BVH ARCHITECTURE

ADDENDUM NO.: #01

DATE: 01/31/2024

PROJECT: Woodhouse Ford Pro: Building Improvements

FLOOR PLAN - FIRE PROTECTION PLAN - AREA C

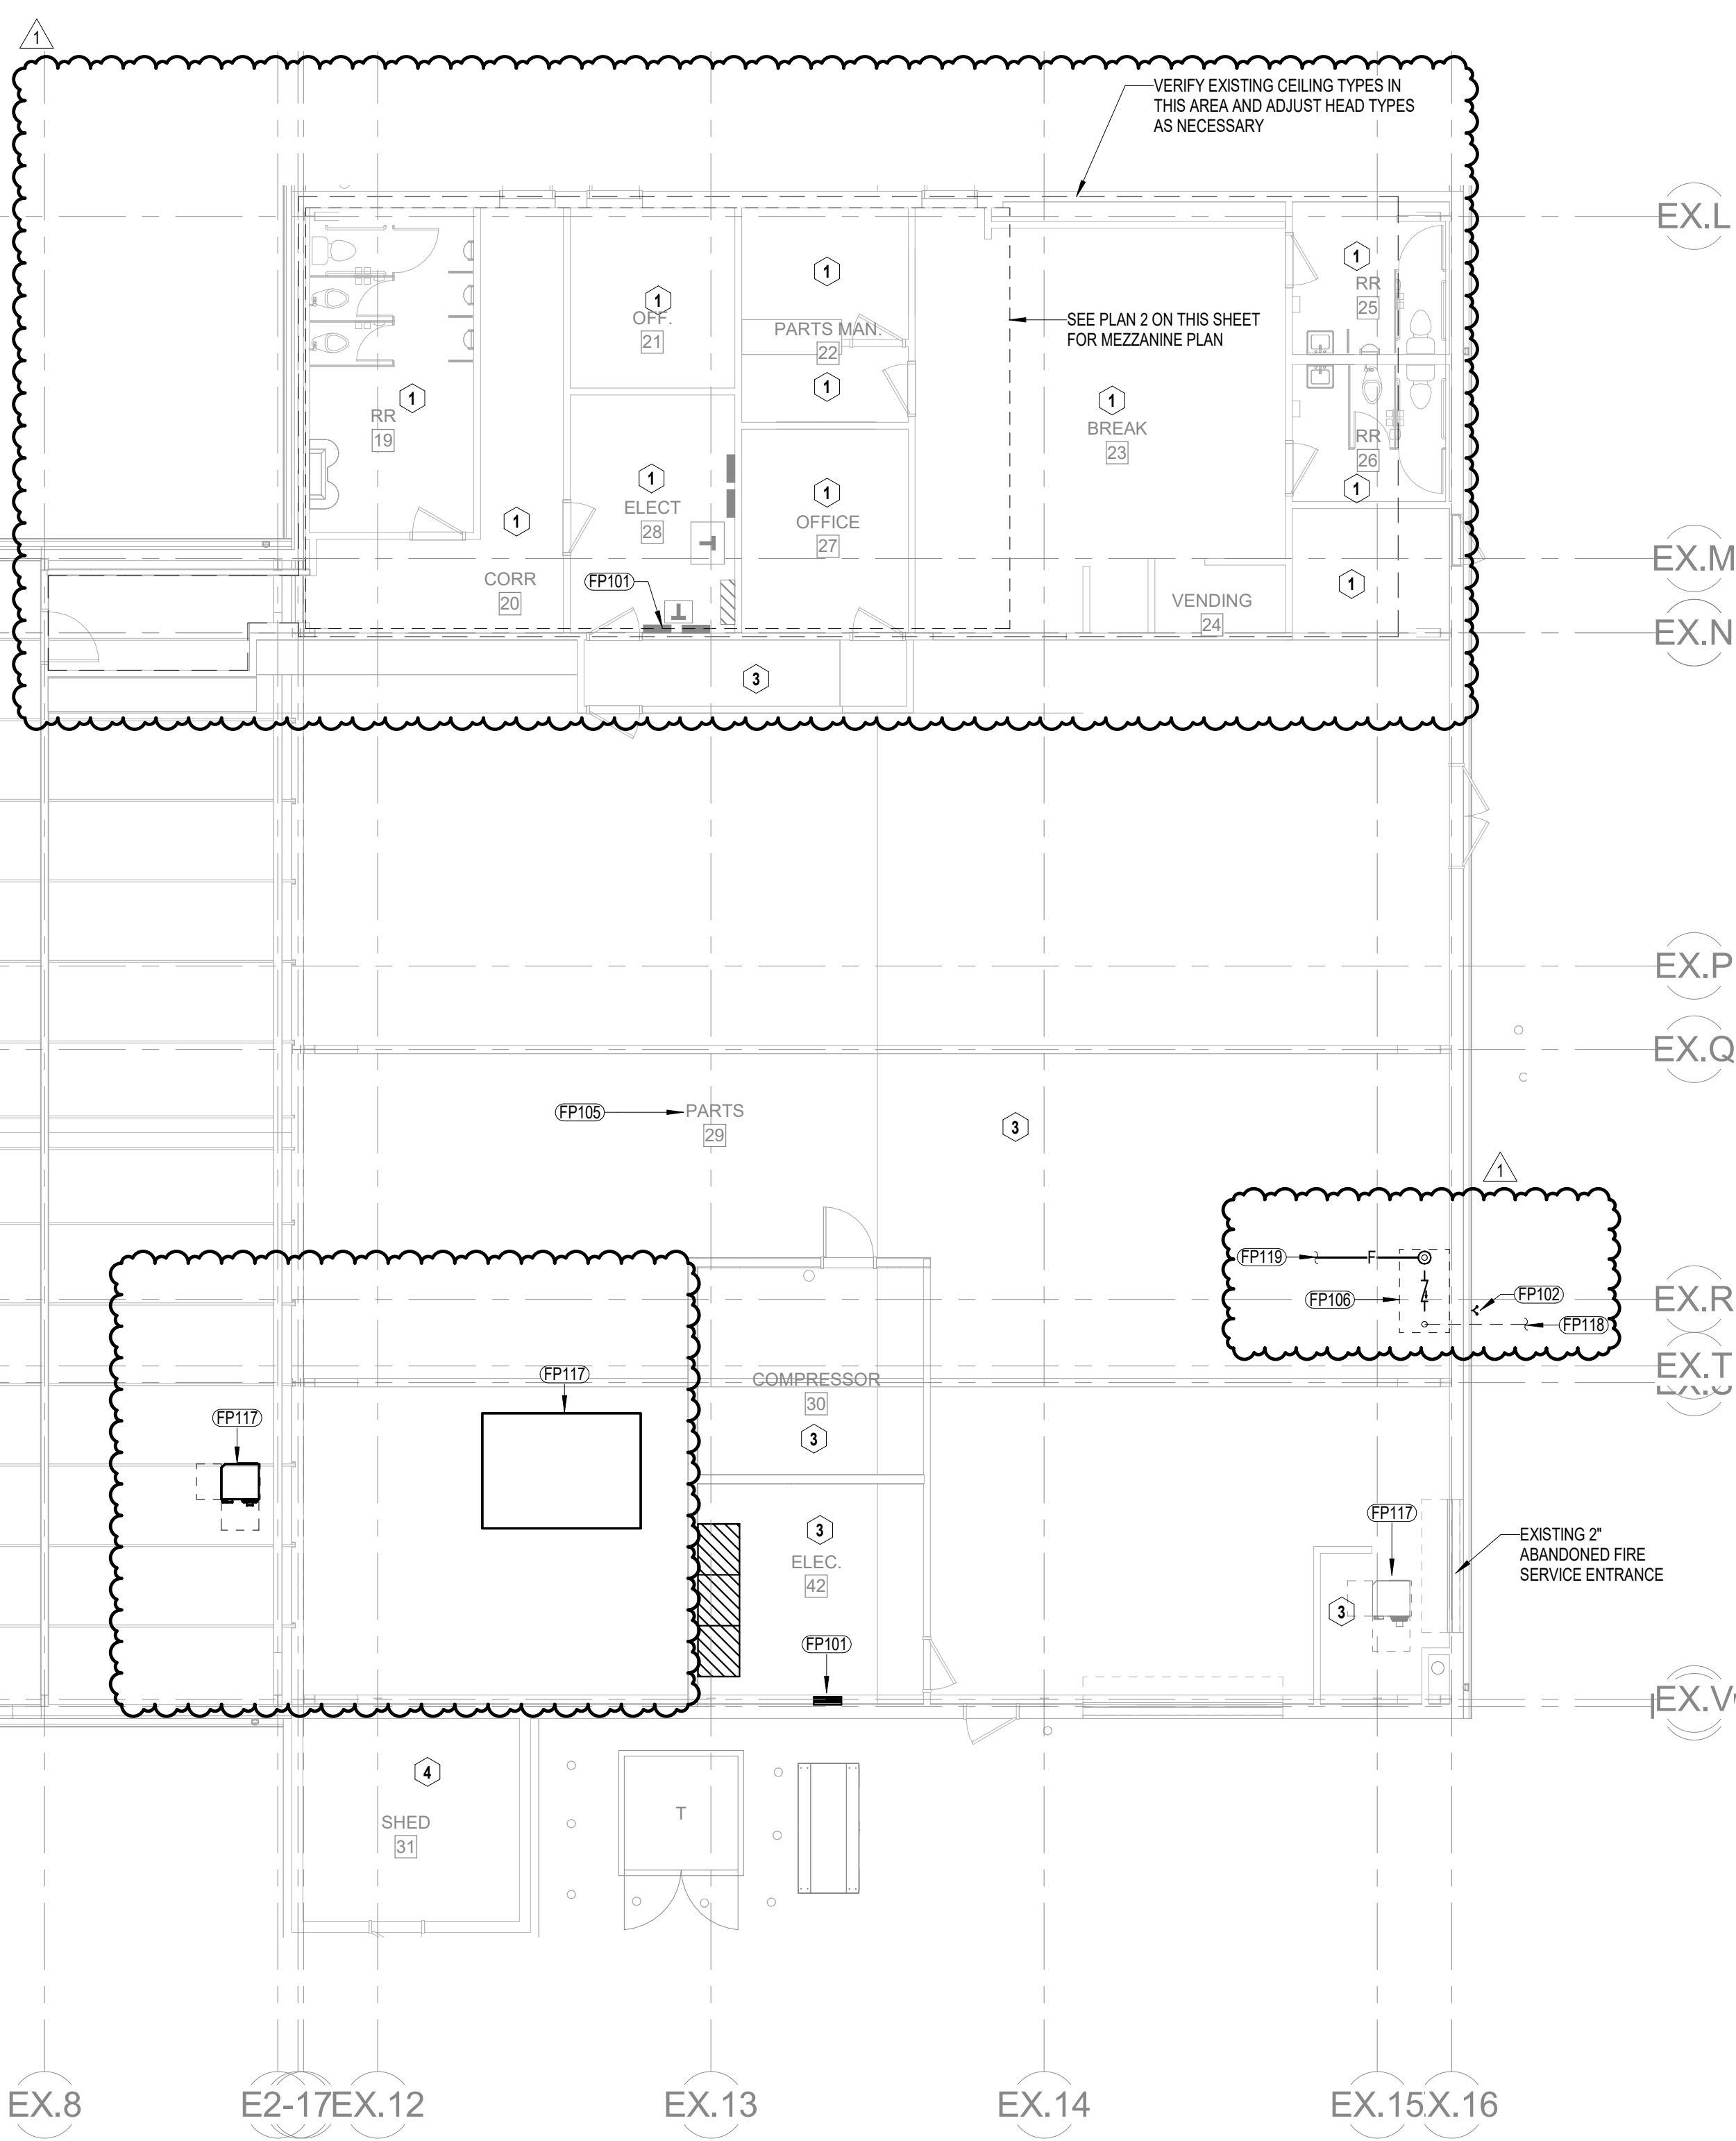
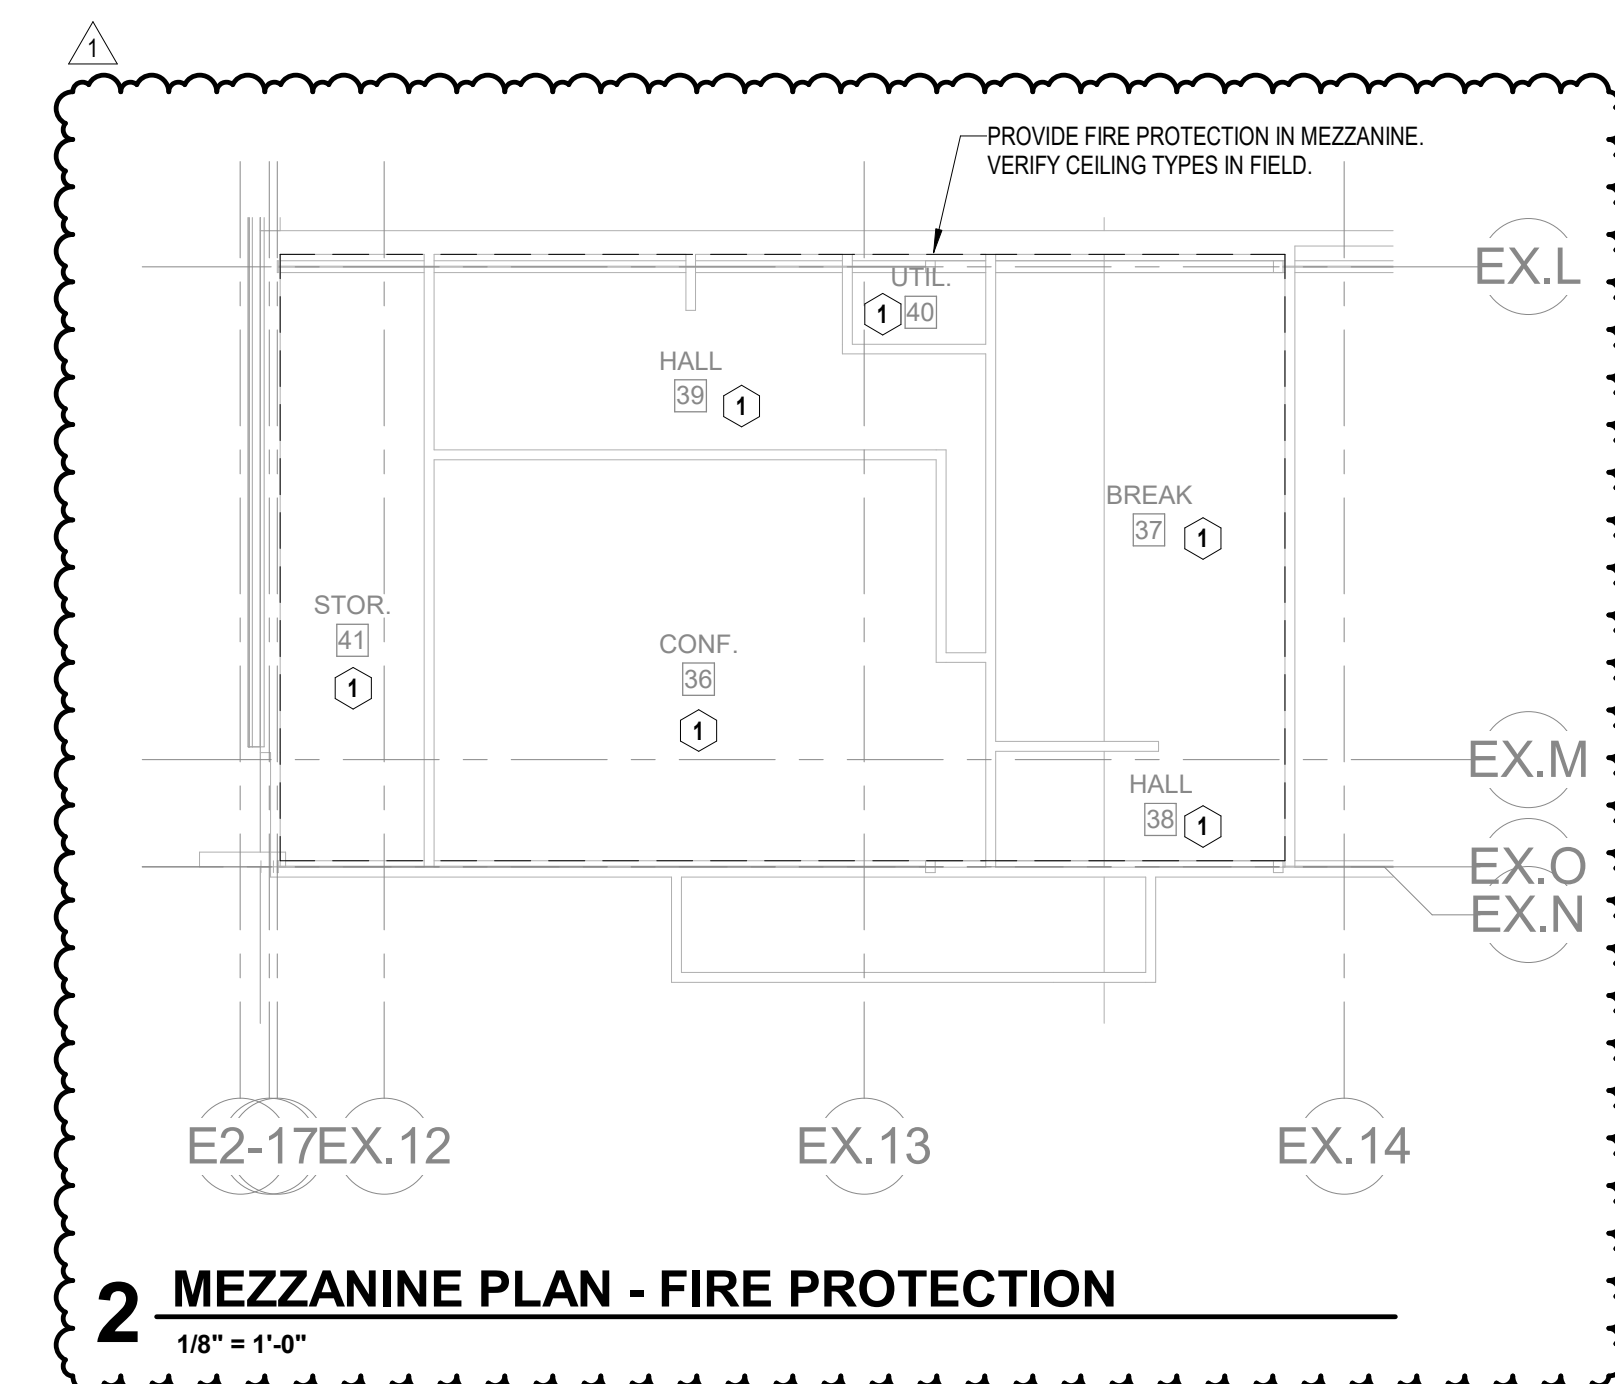
1. Sheet FP1.3 – FLOOR PLAN – FIRE PROTECTION – AREA A
 - a. Add plan showing mezzanine requiring fire protection.
 - b. Add location of fire department connection.

- c. Add notes for fire service design.
 - d. Add notes for avoiding relocated equipment.
2. Sheet MD1.3 – DEMOLITION FLOOR PLAN – HVAC – AREA C
 - a. Salvage AC unit and unit heater for relocation.

1 DEMOLITION FLOOR PLAN - HVAC - AREA C
 1/8" = 1'-0"

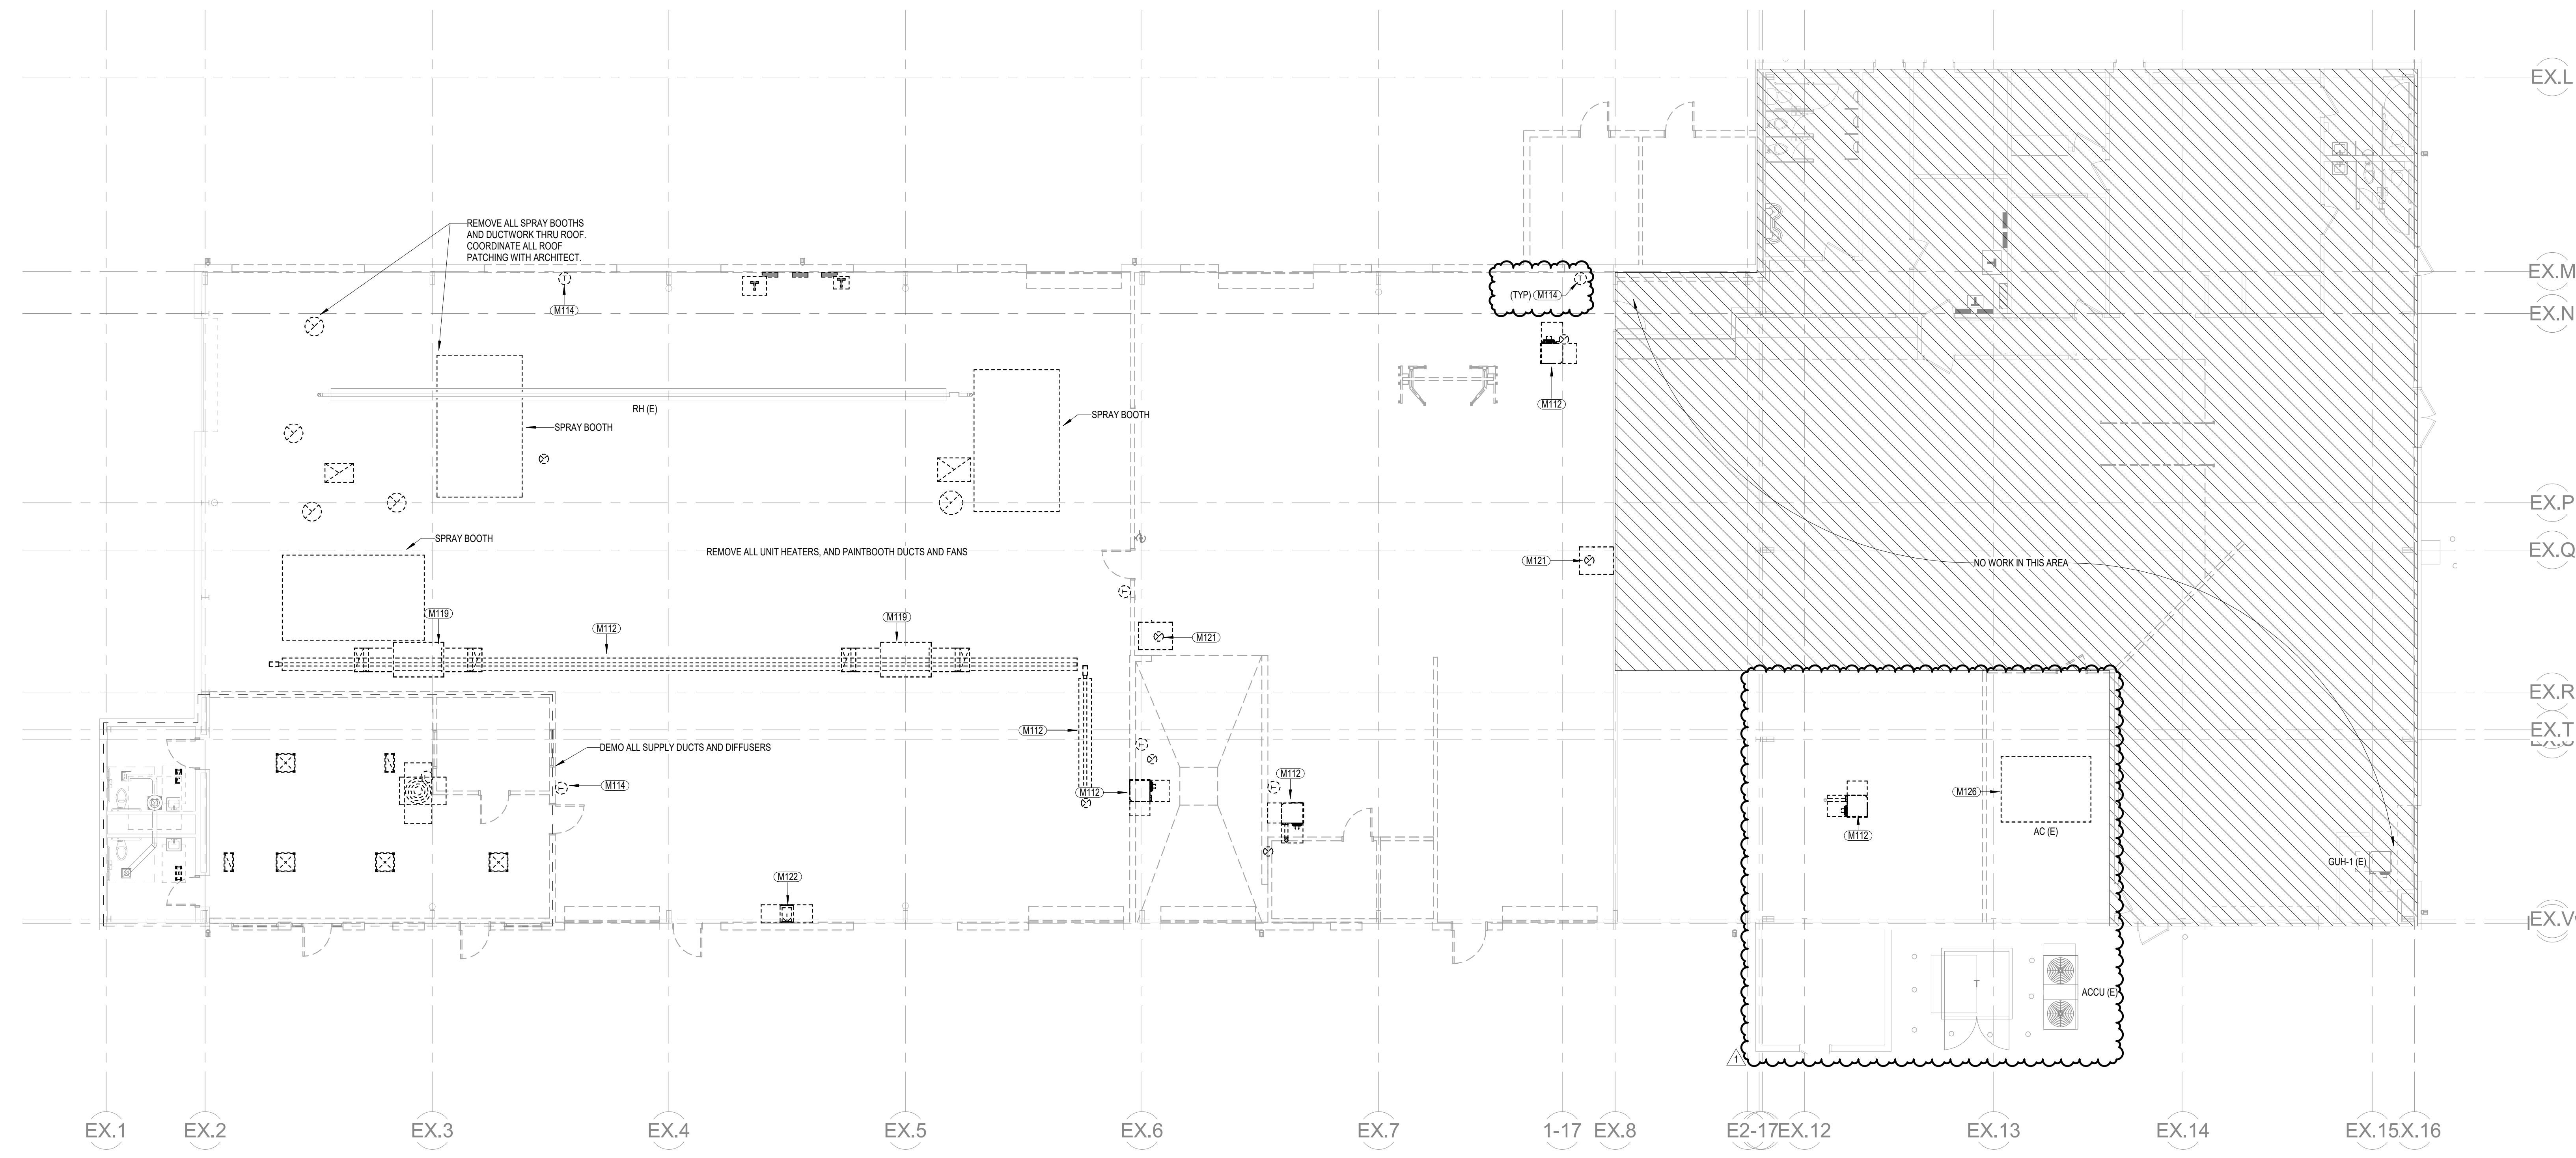
- b. Revised note for thermostats. All thermostats for new and existing equipment within the scope of work to be replaced with new programmable thermostats meeting energy code requirements.
